## **Environmental Minor Project Refinement Form**

Project Name: West of Devers Upgrade Project	Request Prepared By: <u>Sylvia Granados</u>
<ol> <li>Date Submitted: 1/15/2017</li> <li>Devers-Valley, Banning Telecom Route easement at to the west, in the City of Banning, Riverside Count</li> <li>Devers-Valley, Banning Telecom Route easemen immediately to the east, in the City of Banning, Rive</li> <li>Properties immediately adjacent to the Devers-Vall sides of E. Barbour Street, Charles Street, and Victo</li> <li>Intersection of S. San Gorgonio Avenue and Wesley</li> </ol>	t on the north side of Wesley Street and the vacant lot erside County (TEWS #4).  ey, Banning Telecom Route easement, on the north and south bry Avenue, in the City of Banning, Riverside County (TEWS #5) of Street, in the City of Banning, Riverside County (TEWS #5) of Elecom Route easement, south and east of Old Idyllwild Road,
Landowner: <u>Steve Romberg; Carl &amp; Joseph Carri; Todd &amp; Do</u> Moran; Terry & April Porter; David George; Dominguez Jas	onna Currier; Robert Robles; Martha Willis; Socorro & Eloisa

MPR #5 -Old Idyllwild Access Roads and TEWS #3 - #5 Extension

MPR #5 -Old Idyllwild Access Roads and TEWS #3 - #5 Extension

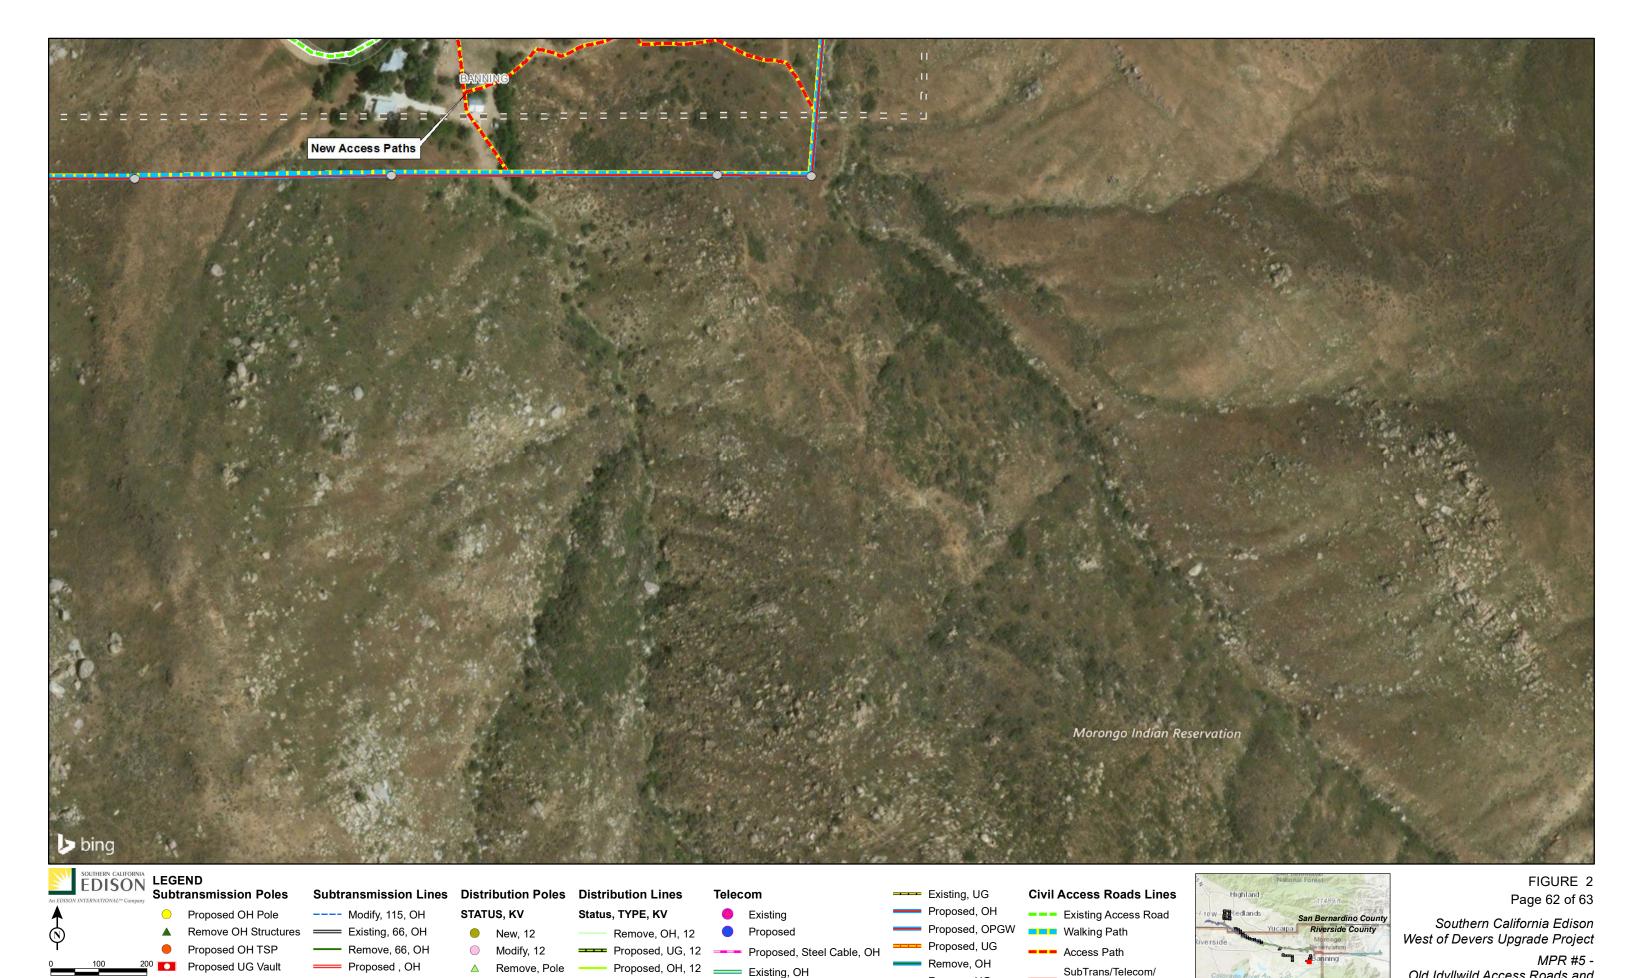
Current Vegetative Cover/Land Use: <u>Developed/Disturbed</u>	
Existing Sensitive Resource? NO ■ YES Specify: <u>See "Bi</u>	ological Resources"
Modifying (check as many as apply): ☐ MITIGA ■ DRAWI	ATION MEASURE
Specify Source (e.g., Mitigation Measure B.5): Continued us #3 Figure 2 Pages 61 and 62.	se of TEWS #3, TEWS #4, TEWS #5, and modification to NTP
<b>Description of Change and Justification</b> (Attach addition (Attach addition)  ■ CONSTRUCTION DRAWING □ ADDITIONAL ENVIRONMENTAL ANALY	·
Continued construction use of access paths approved unde Temporary construction access paths through private properthe City of Banning, CA.	r TEWS #3, TEWS #4, and TEWS #5. erty adjacent to Old Idyllwild Road along the Coyote Trail in
Biological Resources:	
Continued use of TEWS #3: This area was covered during posterior biological resources were observed during the surveys. No sensitive biological resources are anticipated to result from vacant lot adjacent to commercial property.

**Continued use of TEWS #5**: The temporary work areas north of the Coyote Trail are situated in a developed/disturbed environment along existing city streets. The areas are not located in habitats that support special-status plants or

Proposed access paths in the vicinity of Coyote Trail: The proposed access paths are located within existing driveways and established access paths which are characterized as disturbed/developed land. The adjacent habitats are classified as grassland/forbland. The lowland areas adjacent to the two entry points from Old -Banning Idyllwild Road include presumed occupied pockets of Los Angeles Pocket Mouse (LAPM) habitat. The higher elevation areas in the vicinity are not suitable for LAPM. The proposed access paths feature compacted soils and LAPM prefer friable soils. Therefore, LAPM are not expected to occur within the access paths. An LAPM Qualified Biologist reviewed the construction areas along this segment, including the proposed access paths, with the construction foreman and environmental managers. No impacts to LAPM are anticipated assuming construction activities are limited to approved work areas. A Qualified Biologist will be present during construction activities in LAPM habitat to assist the construction crews with locating their equipment and conducting activities to avoid impacts to LAPM.
